# COVERING NOTE

**Subject: Erratum 1 (10/2009) to**

Recommendation ITU-T G.8262/Y.1362 (08/2007), *Timing characteristics of synchronous Ethernet equipment slave clock (EEC)*

**Figure 7 – Lower limit of max tolerable sinusoidal input wander for EEC-Option 1**

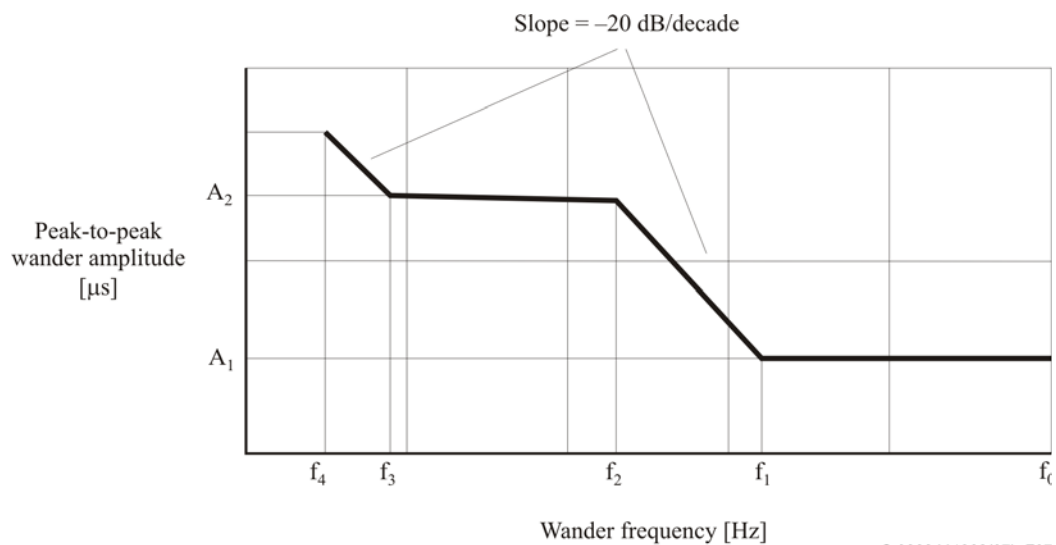
*Within clause 9.1.1, replace Table 8 and Figure 7 with the following representations:*

Peak-to-peak wander amplitude		Wander frequency				
$A_1$ [ $\mu\text{s}$ ]	$A_2$ [ $\mu\text{s}$ ]	$f_4$ [mHz]	$f_3$ [mHz]	$f_2$ [mHz]	$f_1$ [Hz]	$f_0$ [Hz]
0.25	2	0.32	0.8	16	0.13	10
